City of Parramatta	
File No:	DA/837/2022

SECTION 4.15 ASSESSMENT REPORT Environmental Planning & Assessment Act 1979

DA No:	DA/837/2022
Property:	Lot A DP 375159, 183 Macquarie Street, PARRAMATTA NSW 2150
Proposal:	Construction of a 12-storey mixed use building containing ground and first floor retail/commercial space and 76 Co-Living rooms over one level of basement storage
Date of receipt:	25 October 2022
Applicant:	PTI Architecture
Owner:	Rapisarda Holding Pty Limited
Is the property known to be owned by a Council employee or Councillor?	No
Political donations/gifts disclosed:	None disclosed on the application form
Submissions received:	8 submissions
Conciliation Conference Held:	No
Recommendation:	Refusal
Responsible Officer:	Paul Sartor

Figure 5 - Proposed 3D render of loading dock/cafe space

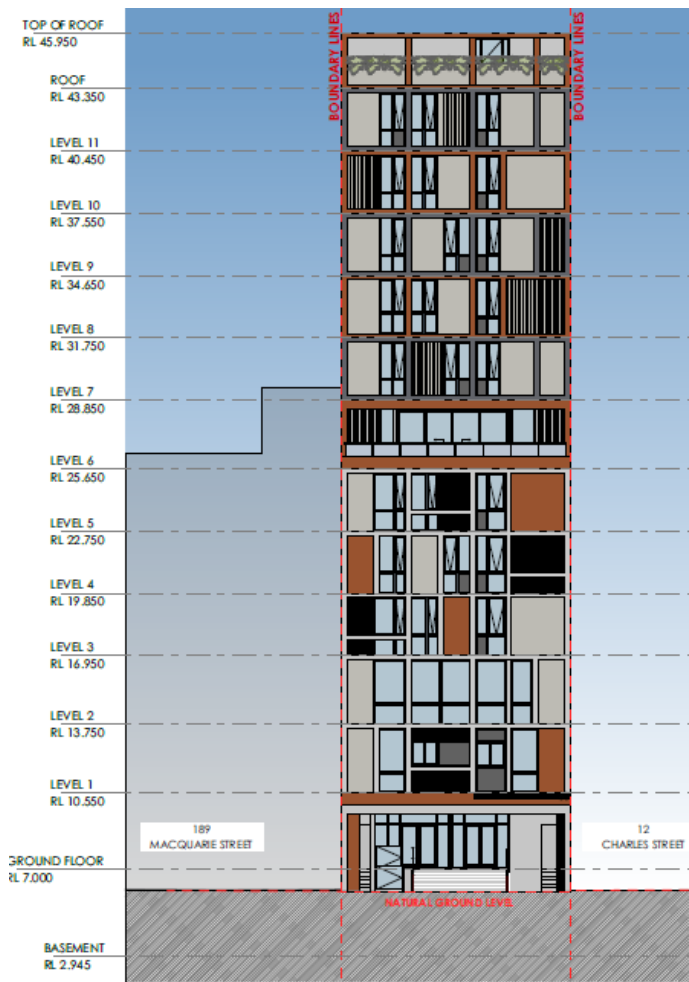
The introduction of vehicular servicing has come at the expense of any active frontage; the entire frontage of the site will present as an open loading dock. The applicant's proposal to co-utilise this space as a seating area for the ground floor retail/commercial unit (i.e. for a café) is not considered to be safe or practicable as it would create conflict between pedestrians and vehicles. Regardless, Transport for NSW are not satisfied with the proposed vehicular access arrangements and have refused to grant concurrence.

- It requires non-compliances with tower side setback controls resulting in unacceptable impacts on built form and amenity.
- The servicing requirements result in no active frontage and create conflict between pedestrians and vehicles.

Figure 9 Screenshot of plans (levels 9-16) for 189 Macquarie St showing proposed tower setbacks to 183 Macquarie St (Source: CDA Architects, 2022)

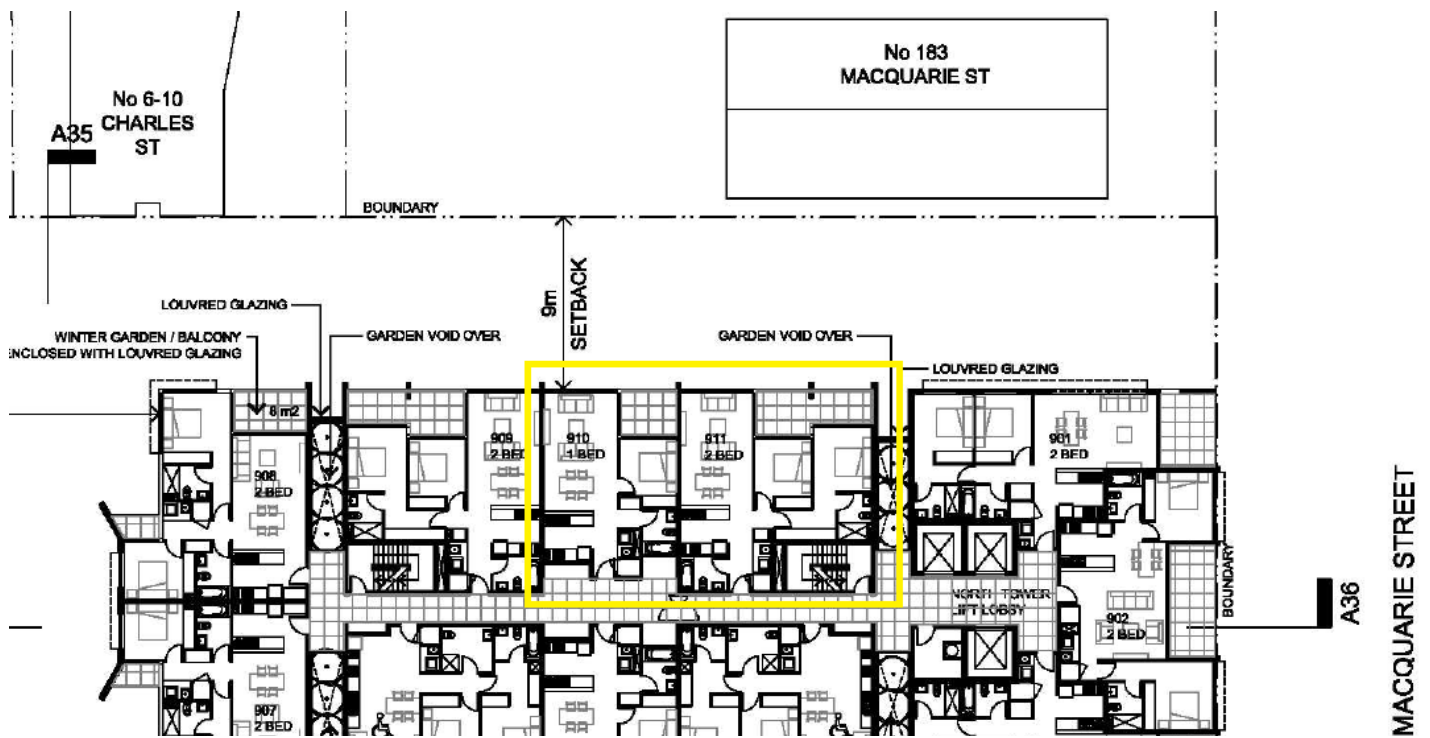
An approval has been granted for a 30 storey multi tower development above the carpark (DA/852/2013). The approved tower would have a 9m setback to the shared boundary, which, whilst not the required 12m shared ADG setback (above level 8), was considered acceptable for a CBD setting (See Figure 9 below).

The proposed development still provides a zero-lot side tower setback except for the lightwell. The lack of a side setback results in the inability to provide side windows, which would increase natural cross ventilation and solar access. Further, the lack of setback and provision of a blank wall would result in unacceptable outlook impacts for several of the units at Levels 6 – 12 of the approved development (particularly those highlighted in yellow on the drawing).

Figure 11 - Sample floor plan of concept provided for 12 Charles St property

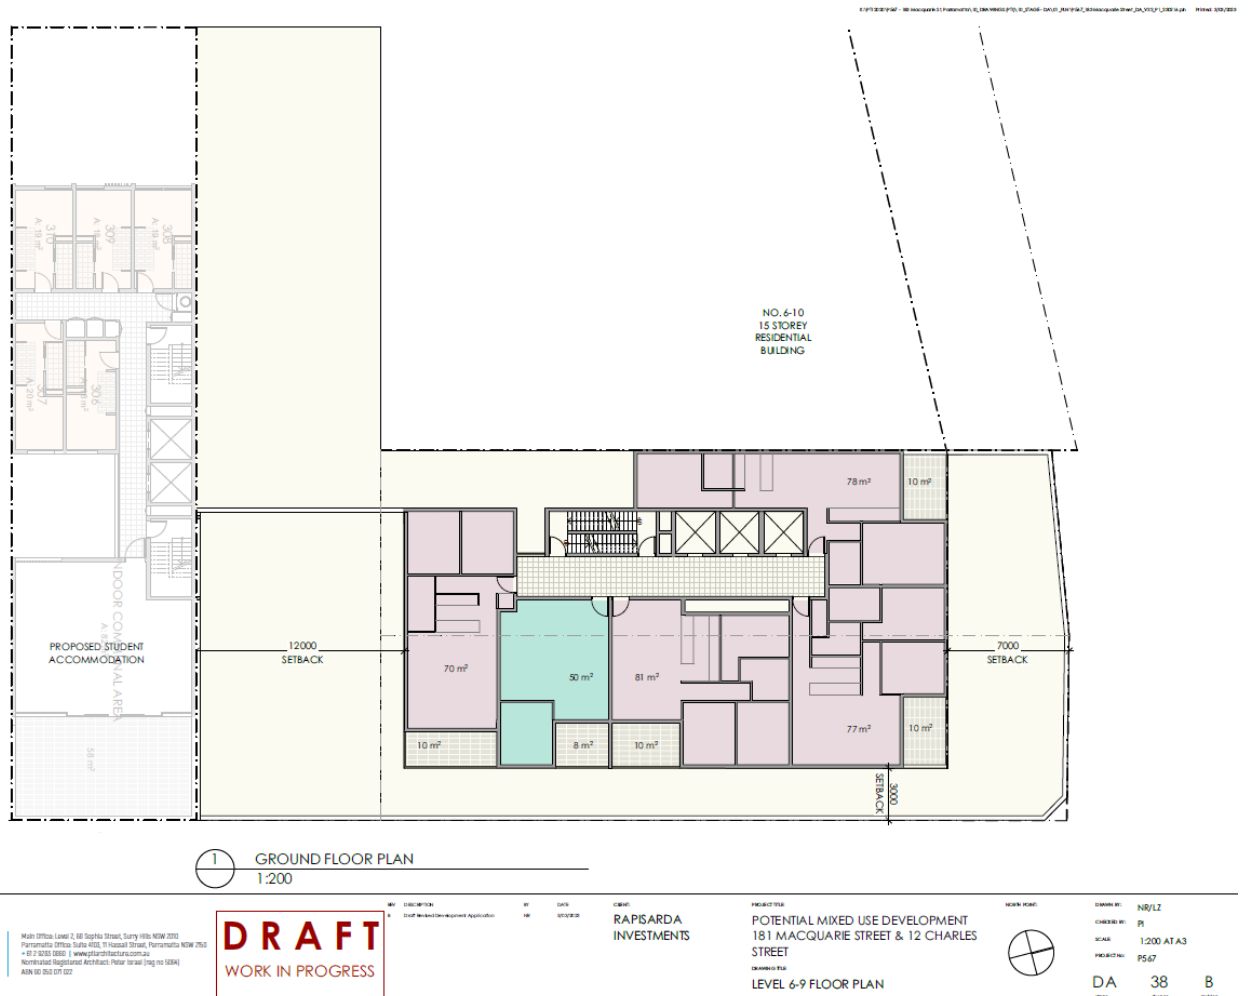
The applicant, as part of their draft RFI response on 3 March 2023, provided a concept for the adjoining site (see Figure 11 below). This concept shows the adjoining site providing the full 12m non-habitable to non-habitable separation. The applicant has not demonstrated that this floorplate would achieve the full FSR allowable for those lots (i.e. up to 11.5:1 per cl. 7.3(4) of the PLEP)). Given the high allowable density controls it is likely that the owner would seek to first develop the easternmost lot of 12 Charles St, being identical in size and dimensions to the subject site, in keeping with the subject proposal, while the 2 western lots would be developed separately. Given the shallow depth of the western lots (north-south), it is likely that they would seek to also provide no eastern setback, and potentially a reduced northern setback, resulting in an unbroken continuous and imposing tower form along this part of Macquarie Street. It would be more appropriate for the subject site to combine with the eastern lot of 12 Charles, and for the other 2 lots of 12 Charles to be developed independently, with an appropriate separation between the two towers.

The applicant stated at the last LPP meeting that they had offered to consolidate with all or part of 12 Charles St in 2018. Evidence of this offer was never provided to Council. Further, as this offer was from 6 years ago it is out of date, and no offers have been provided since to prove that this site is effectively isolated and cannot reasonably be developed as part of a larger site.
